### Evaluation of proposed move for Water Right No. 7195 D1

Proposed: Move water right no. 7195 D1 ID7 to a new well location 637 ft to the north.

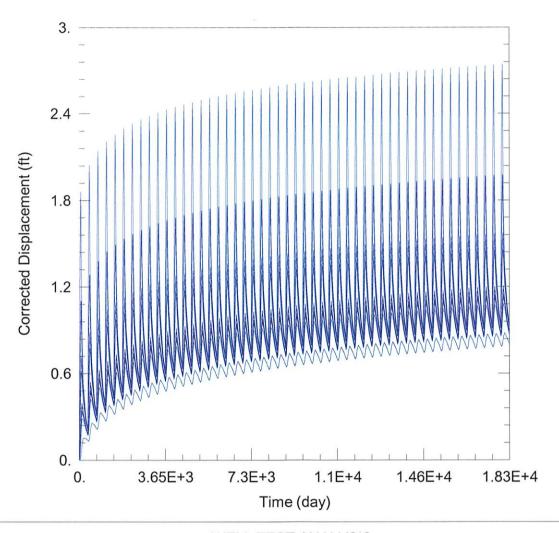
The saturated thickness at the proposed well location is estimated to be 260 ft, based upon the GMD3 model. For saturated thickness greater than 200 ft, the drawdown allowance is 4.0 ft.

Net drawdown exceeds the drawdown allowance of 4.0 ft for water right nos. 16536, 38993, 38991, and domestic wells 1, 2, and 4. Critical well analysis is necessary for those wells.

The proposed moves are located in an area with ample saturated thickness and aquifer properties that allow for productive wells. If the proposed well were to pump its full authorized authority, there would likely be a noticeable effect on a few neighboring wells. Critical well analysis shows that none of these neighboring wells are critical, meaning that they are not likely to lose a significant amount of productivity because of this change. GMD3 staff recommends approval of the application.

### WELL TEST ANALYSIS

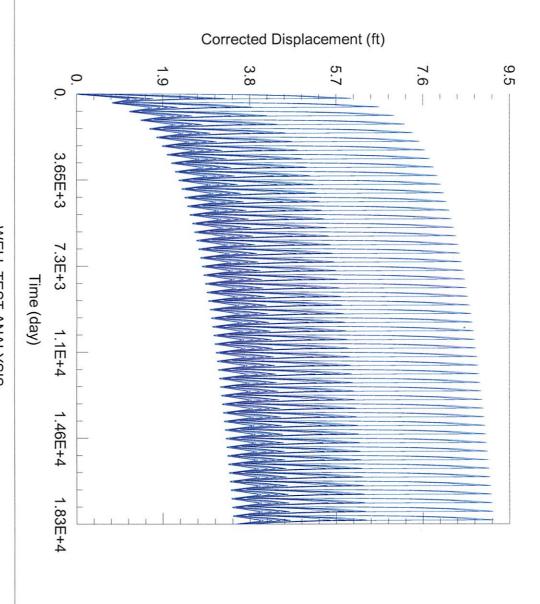
S = 0.149, T = 13,773 ft<sup>2</sup>/day,  $tp_{current} = 75$  days,  $Q_{current} = 896$  gpm,  $tp_{proposed} = 199$  days,  $Q_{proposed} = 1250$  gpm (Note that the current well location has not been used over the past 10 years. This right has a limitation with 7195 D1 ID8, and as a worst-case scenario, analysis was run as if all authority was pumped out of the proposed well location. Current effects are from 7195 D1 ID8.)
